SUBJECT: Addendum No. 4

REFERENCE: Invitation To Bid (ITB) for HOU Restroom Renovation Phase 2; Solicitation No. HHG-HRESTR-2022-019; Project No. PN209A

NARRATIVE ADDENDUM NO. 4

SHEET NAME: GENERAL NOTES
SHEET No. G-003 SCALE: 1/4" = 1'-0"

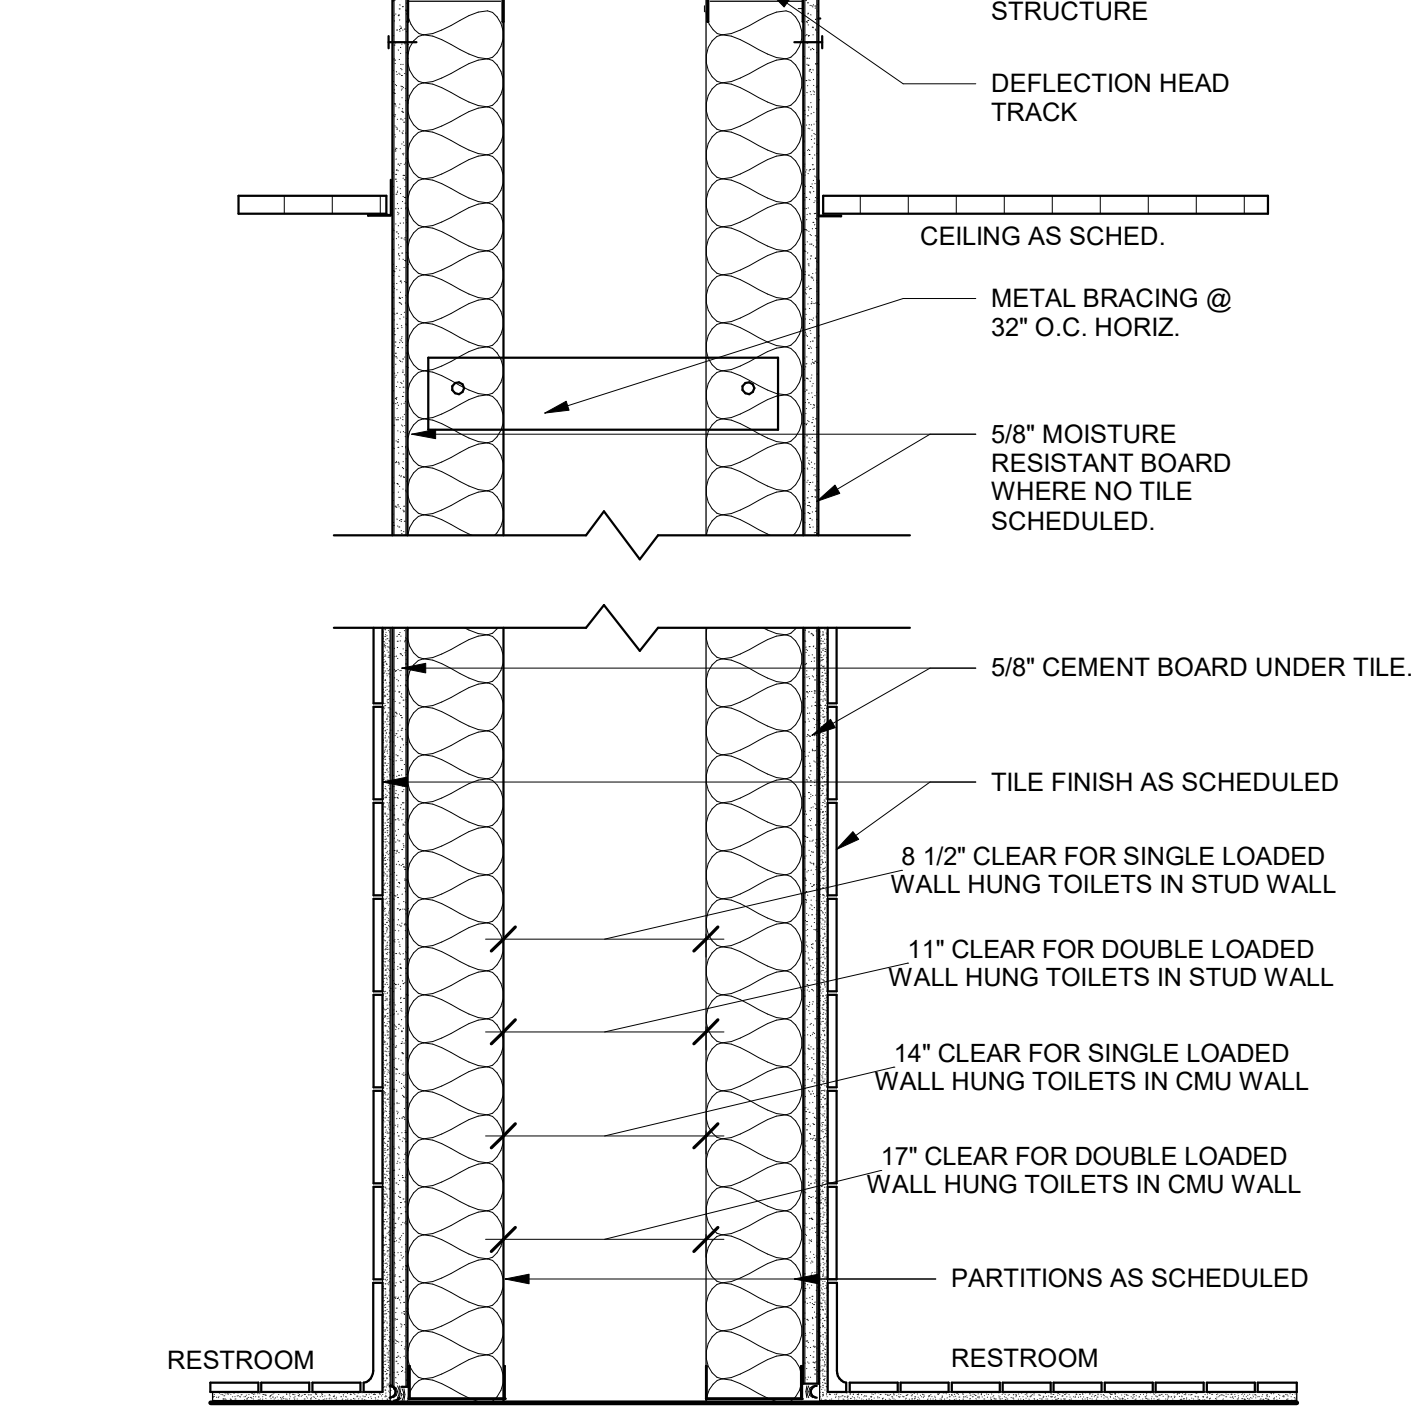
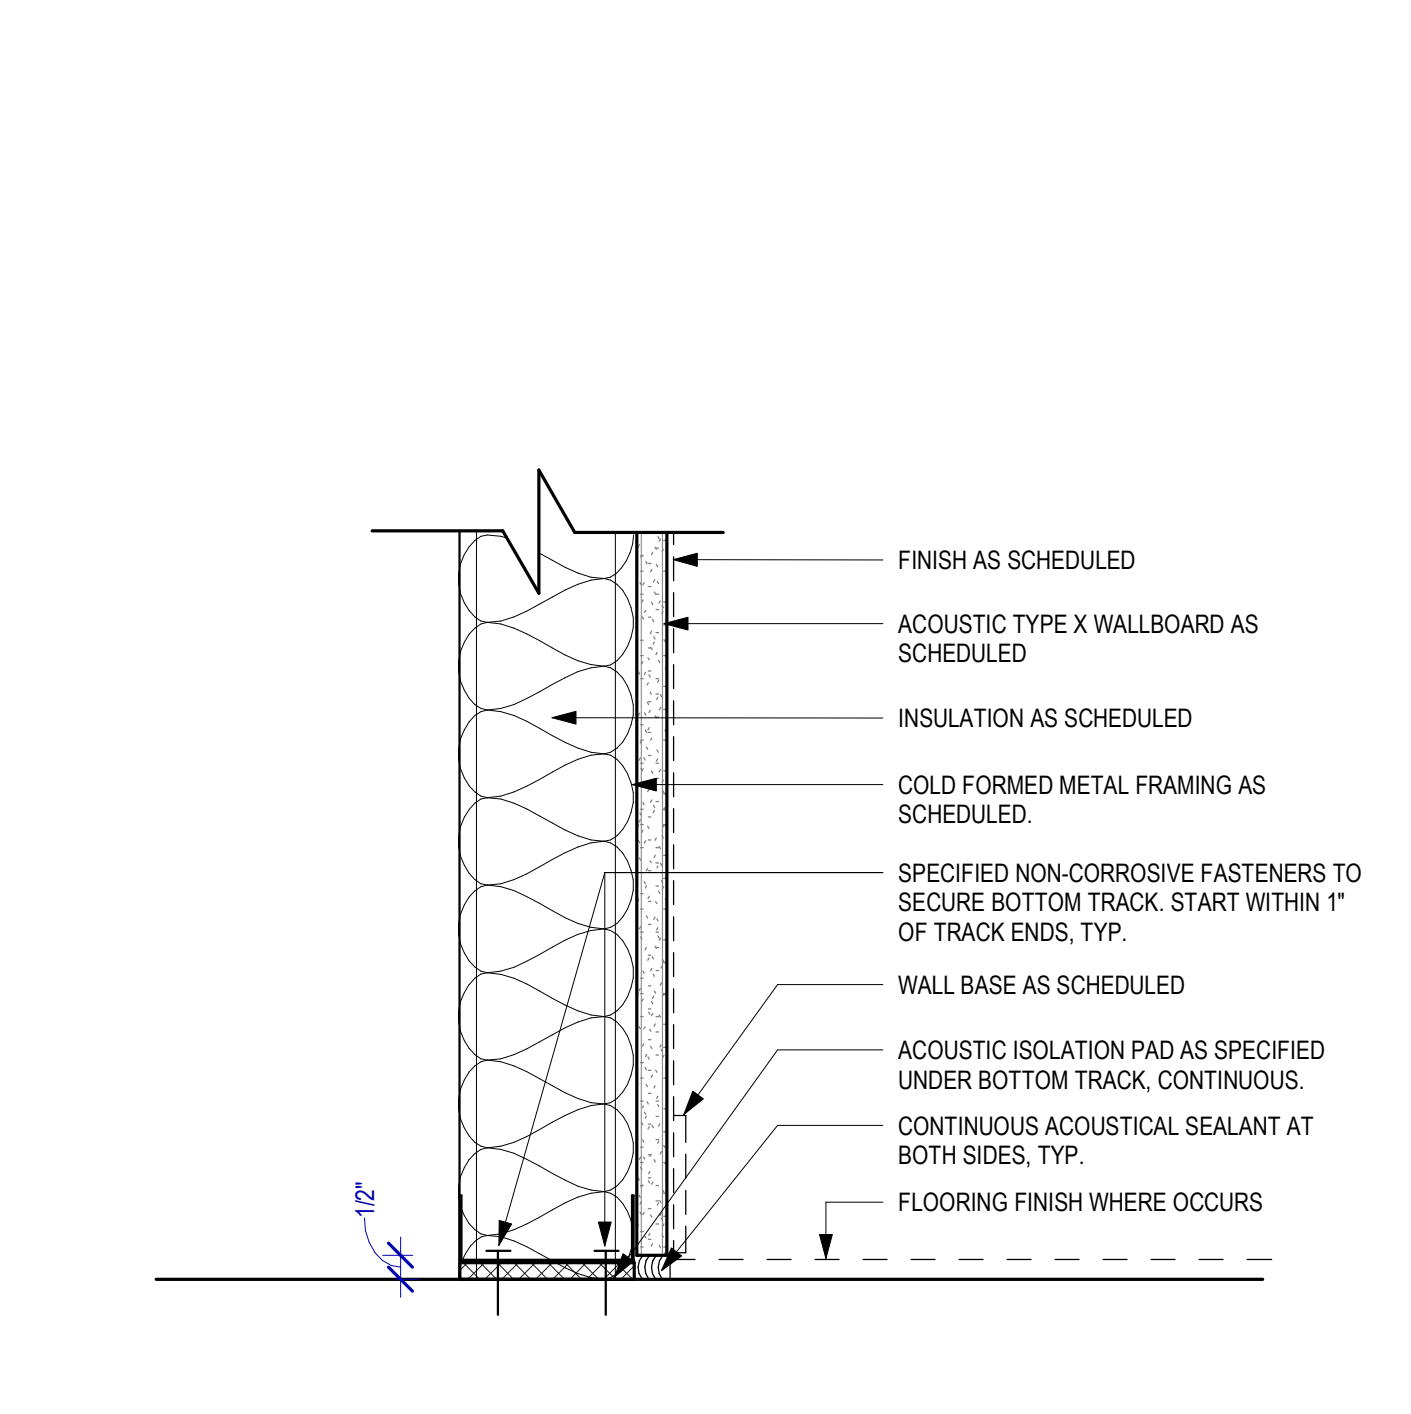
Item	Reference Drawing(s)	Description
	G-003	a. Special Inspections Note 2 revised to read: Special inspections "retained by the owner". b. The following wording "wood platform and precast terrazzo planter" was removed from Note 2 of Architectural Systems.
	G-010	Dust Fence Detail B2/G010 added.
	G-042	a. Dust wall dimensions added. b. Floor plan Legend Revised. c. Construction phasing note # 4 revised to read: Dust fence partition to be min. 8' AFF, TYP.
	AD-101, AD-102, AD-103	Dust wall information removed.
	A-101	a. Toilet Accessories legend and Plumbing fixtures legend updated: 1. Not used items PC4, PC5 and PS1 were deleted. 2. Lovair accessories were renamed as Splash Lab USA. ID information updated for PF-1, PF2, PO-1, PL-1, and PL-2. 3. PM-1 Carvart Frameless LED Mirror Added. 4. TF-1 model # revised to read: 461202. b. Soap dispenser location symbol revised in the floor plan.
	A-102	a. Toilet Accessories legend and Plumbing fixtures legend updated: 1. Not used items PC4, PC5 and PS1 were deleted. 2. Lovair accessories were renamed as Splash Lab USA. ID information updated for PF-1, PF2, PO-1, PL-1, and PL-2. 3. PM-1 Carvart Frameless LED Mirror Added. 4. TF-1 model # revised to read: 461202. b. Soap dispenser location symbol revised in the floor plan.

SHEET NAME:
REFLECTED CEILING PLAN - GATE 20-23 RESTROOMS
SHEET No. A-140 SCALE: 1/4" = 1'-0"

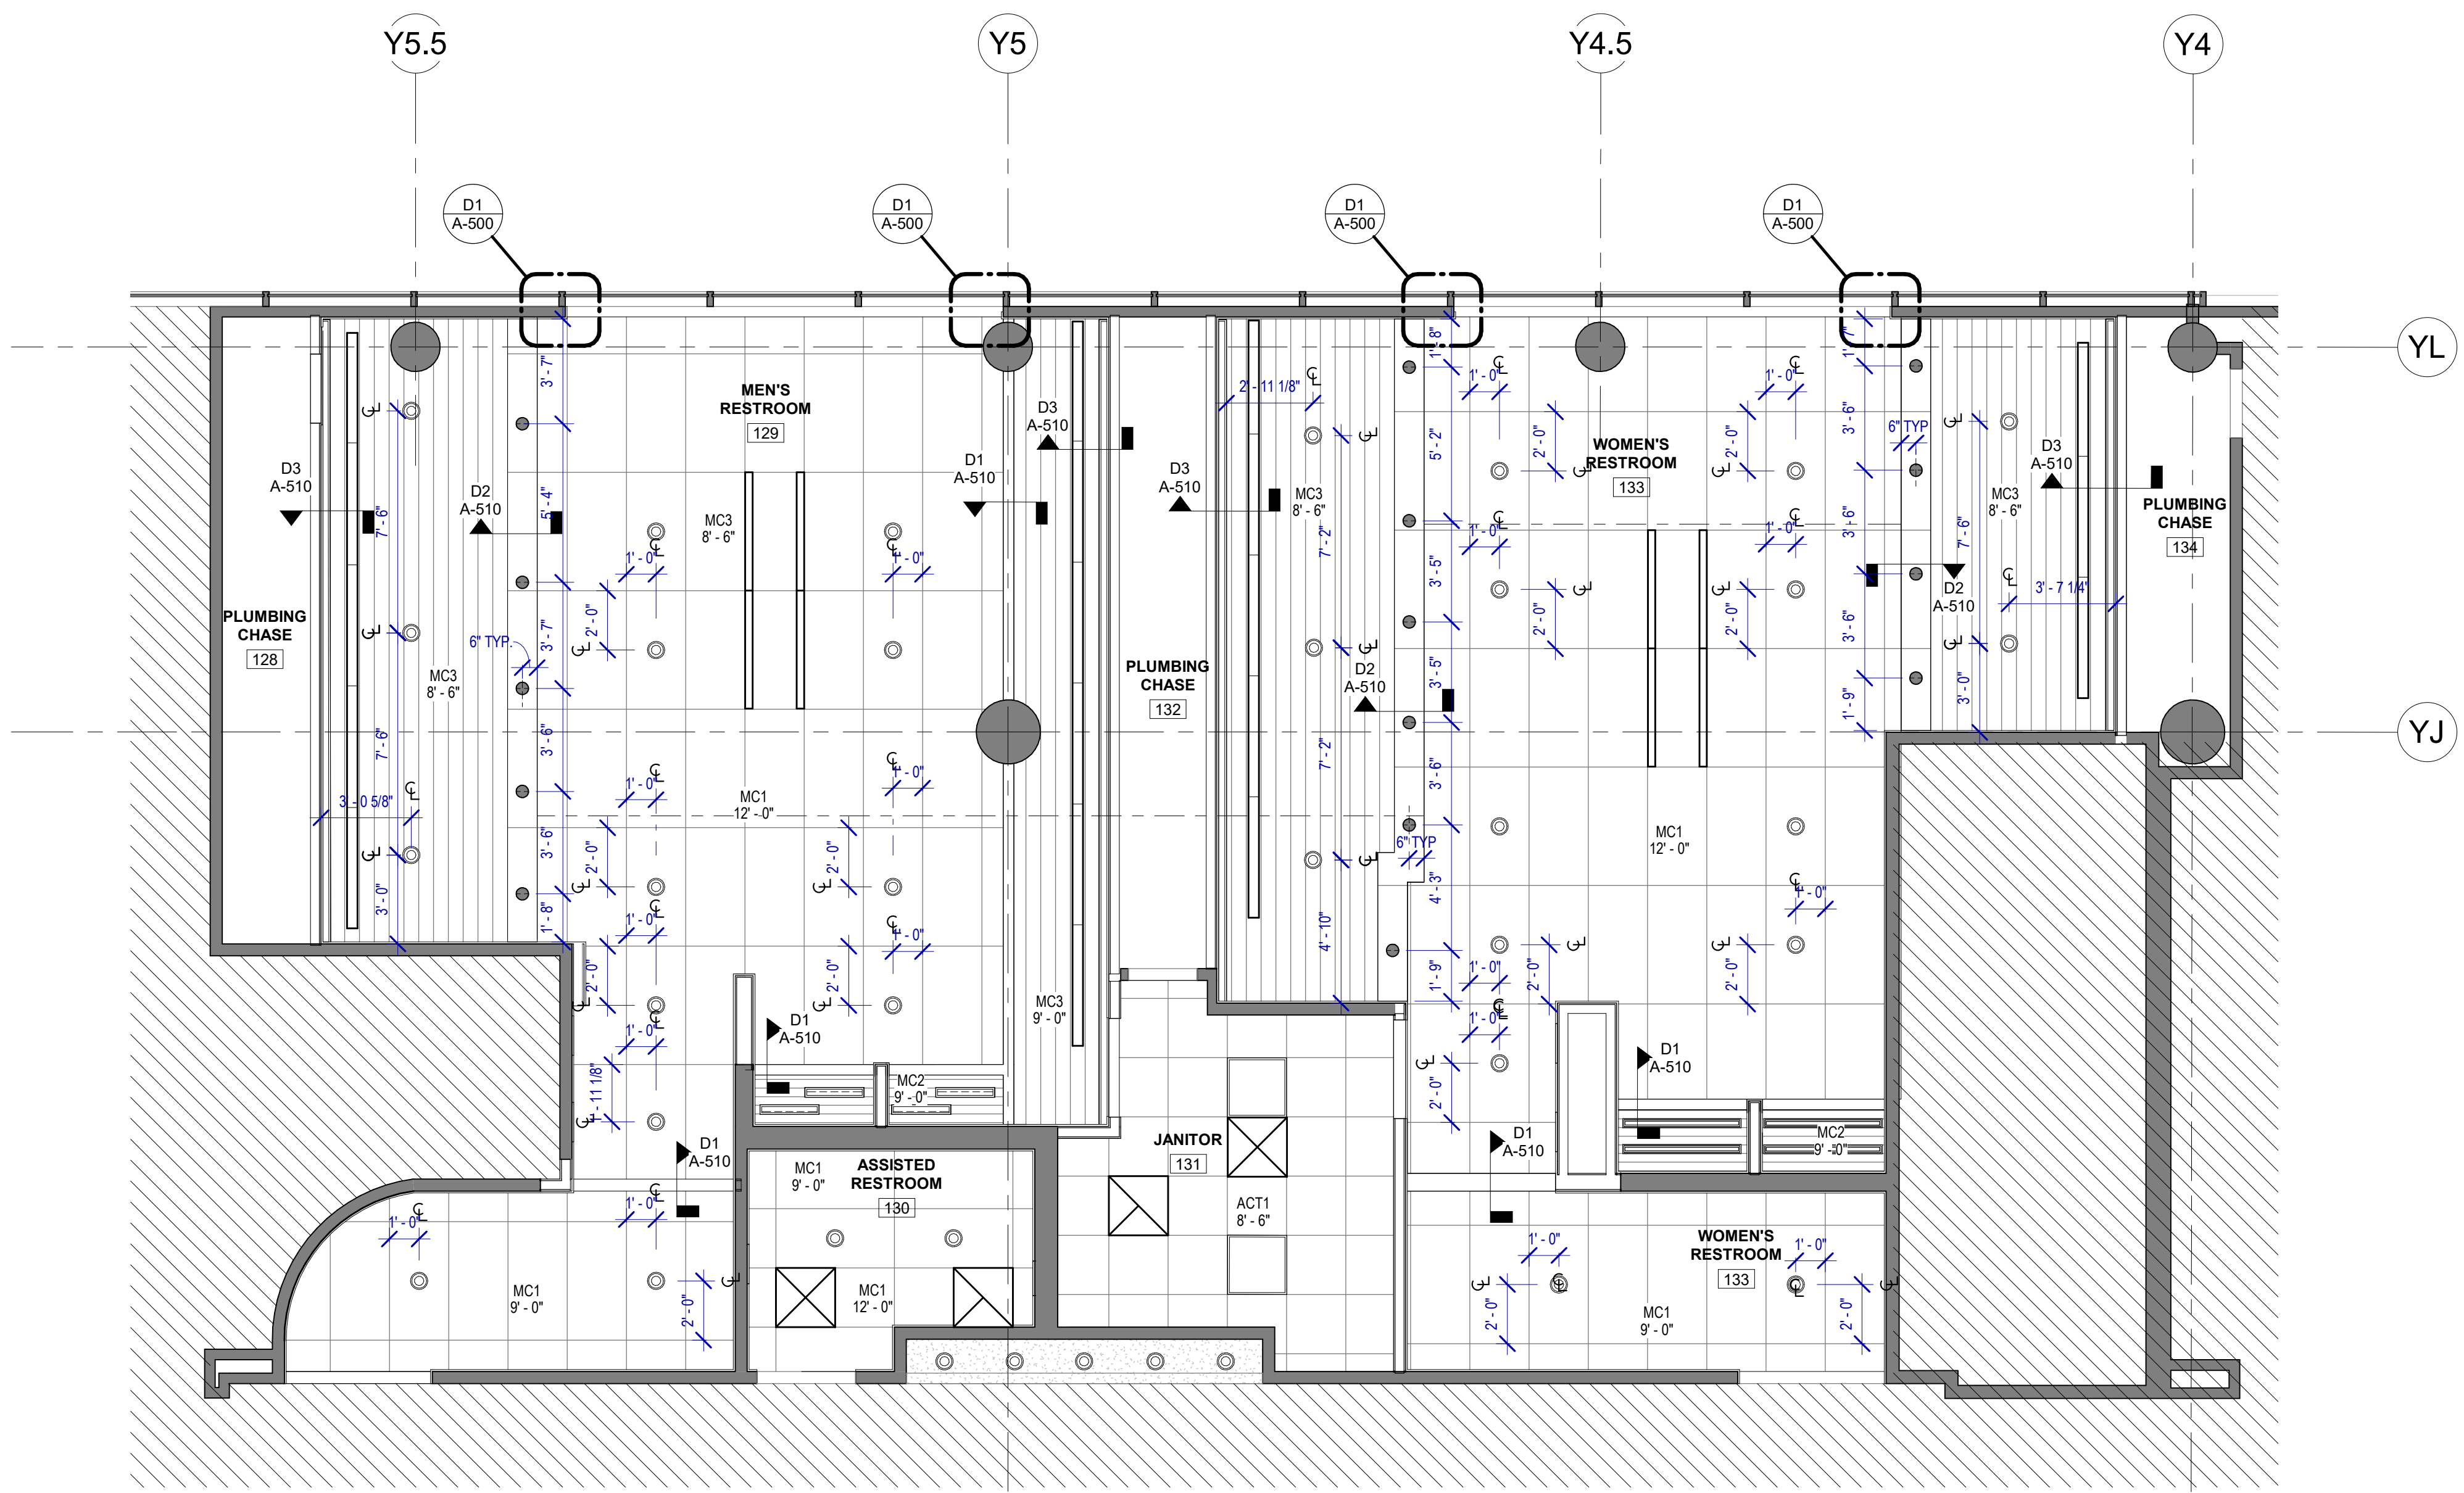
A-140, A-141, A-142	RCP General Notes #6 wording revised: "SOUTHWEST AIRLINES" replaced with "HAS RESTROOM STANDARDS"
	A-420	<ul style="list-style-type: none"> a. Toilet Accessories legend updated: <ul style="list-style-type: none"> 1. Not used items PC4, PC5 and PS1 were deleted. 2. Lovair accessories were renamed to read Splash Lab USA. ID information updated for PF-1, PF2, PO-1, PL-1, and PL-2. 3. PM-1 Carvart Frameless LED Mirror Added. 4. TF-1 model # revised to read: 461202. b. Detail C3 Revised. <ul style="list-style-type: none"> 1. Lavatory Island Elevation revised. 2. Symbol PM-2 revised to read PM-1. c. Detail B3 Revised. <ul style="list-style-type: none"> 1. Lavatory Island Elevation revised. 2. Mirror PM-1 revised. d. TF-1 Label added on Detail A3
	A-421	<ul style="list-style-type: none"> a. Toilet Accessories legend updated: <ul style="list-style-type: none"> 1. Not used items PC4, PC5 and PS1 were deleted. 2. Lovair accessories were renamed to read Splash Lab USA. ID information updated for PF-1, PF2, PO-1, PL-1, and PL-2. 3. PM-1 Carvart Frameless LED Mirror Added. 4. TF-1 model # revised to read: 461202.
